Subject: Request for Additional Information #1 Regarding, FutureGen Applications for UIC Permit nos. IL-137-6A-0001, -0002, -0003 & -0004, dated October 31, 2013

10-31-2013: Letter from Rebecca Harvey (EPA) to Kenneth K. Humphreys (Alliance), "Request for Additional Information Regarding four FutureGen 2.0 Wells, United States Environmental Protection Agency Underground Injection Control (UIC) Permit Applications for Four Geologic Sequestration Wells; United States Environmental Protection Agency UIC Permit Nos. IL-137-6A-0001, -0002, -0003, & -0004"

Appendix A

Additional Information Regarding
Seismic Reflection Survey
and
Vertical Seismic Profiling Data

Figure 1. Location of Seismic Data Acquired for Characterization of the Morgan County Site.

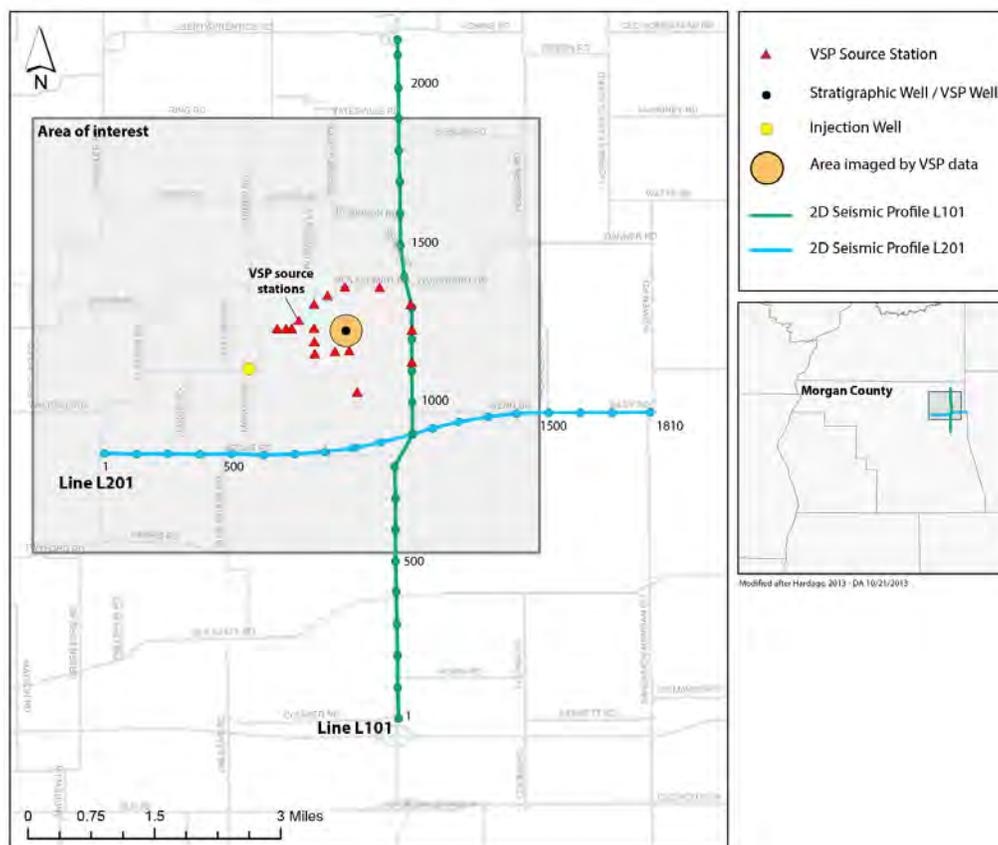
The following discussion addresses the specific request for additional information regarding 2D-seismic profiles and vertical seismic profiling data (RAI# 10-31-2013_001).

Figure 1 shows the locations where these data were acquired, relative to the stratigraphic well and the proposed injection well.

Figure 4.4 Injection Well Schematic – Cased-Hole Completion (geology and depths shown in this diagram are based on site-specific characterization data obtained from the FutureGen 2.0 stratigraphic well)

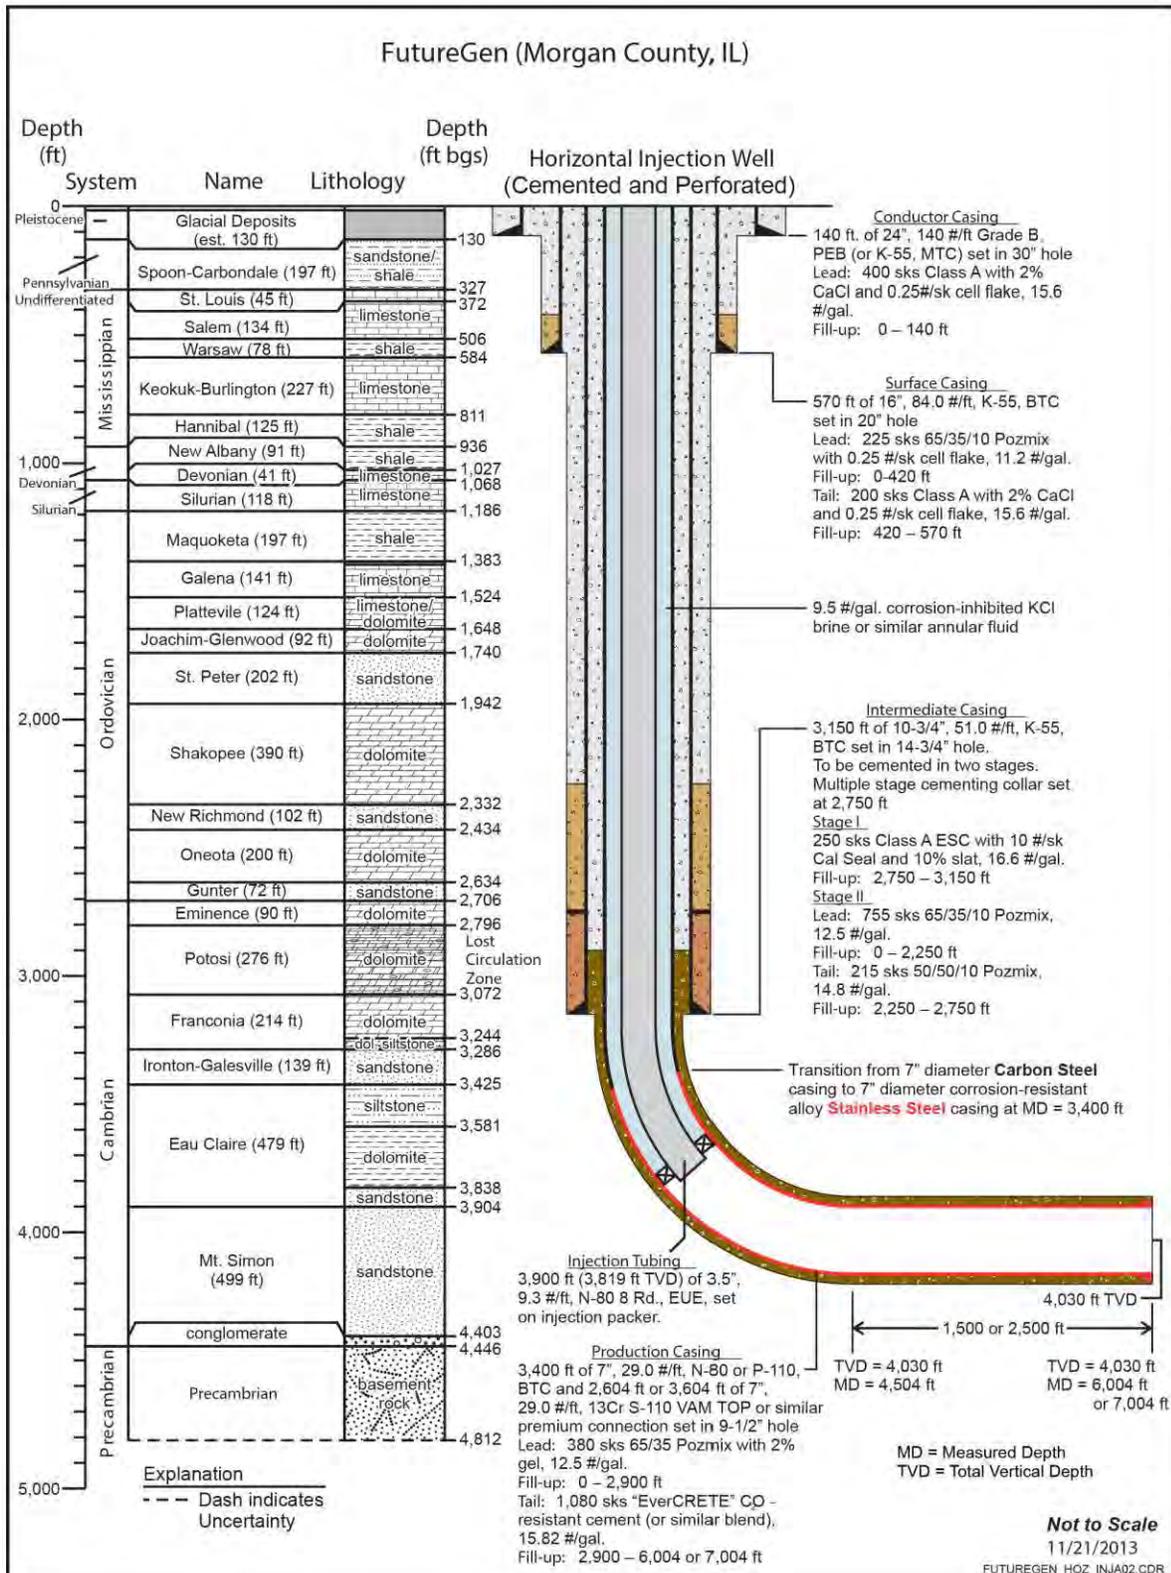
10-31-2013_007	EPA Form 7520-14		6		<p>EPA Form 7520-14 (Plugging & Abandonment Plan) is missing.</p> <p>EPA: Please provide for each well.</p>	<p>EPA Form 7520-14 has been completed for open-hole and cased-hole completions with laterals of 1,500 ft and 2,500 ft (4 forms, in Appendix B). These forms were unintentionally missing in the UIC Permit Application and are being submitted with this response.</p>	
10-31-2013_008	EverCrete Cement Information		6		<p>Information concerning the slurry volume and slurry weight of the EverCrete cement is needed</p>	<p>(1) The slurry volume (yield) is 1.12 ft³/sack. (2) The slurry weight is 15.82 lb/gal. (3) Lab analyses of the EverCRETE-5 cement blend and a technical report are also attached (Appendix C).</p> <p>Note that the Alliance plans to use a Class H cement, and the product brand, EverCRETE-5, is an example of a class H cement.</p>	
10-31-2013_009	Casing & Retainer in Figure 6.2	6.5	6		<p>In Figure 6.2, the 7" casing is set at 3400 feet, however a cement retainer will be at 3900 feet, which is below the cased hole.</p> <p>EPA: Please correct.</p>	<p>The carbon-steel casing will be run to a depth of 3,400 ft and stainless steel casing will be run from 3,400 ft to 3,950 ft. For clarity, an updated version of Figure 6.2 is attached in Appendix D. For consistency, Figures 4.4, 4.5, and 6.1 have also been updated and are provided in Appendix D.</p>

Figure 6.2. Diagram of Non-Cased Injection Well After Plugging and Abandonment

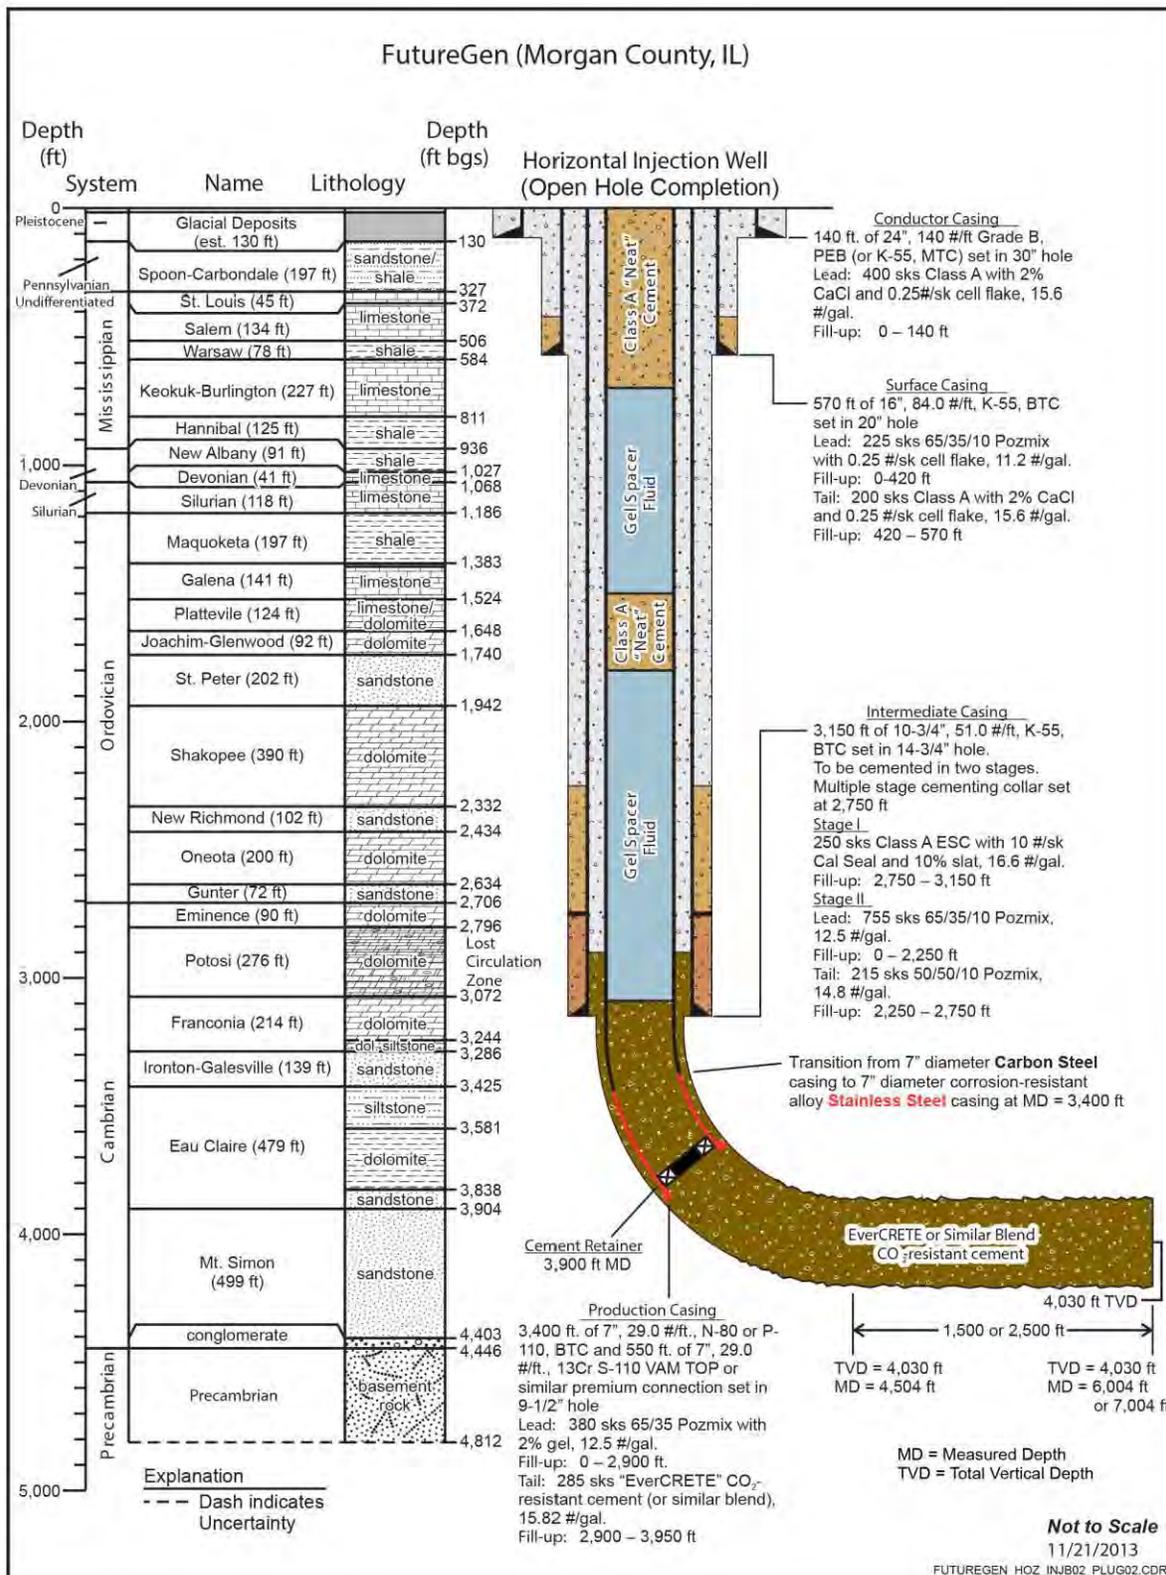
RAI# 10-31-2013_009
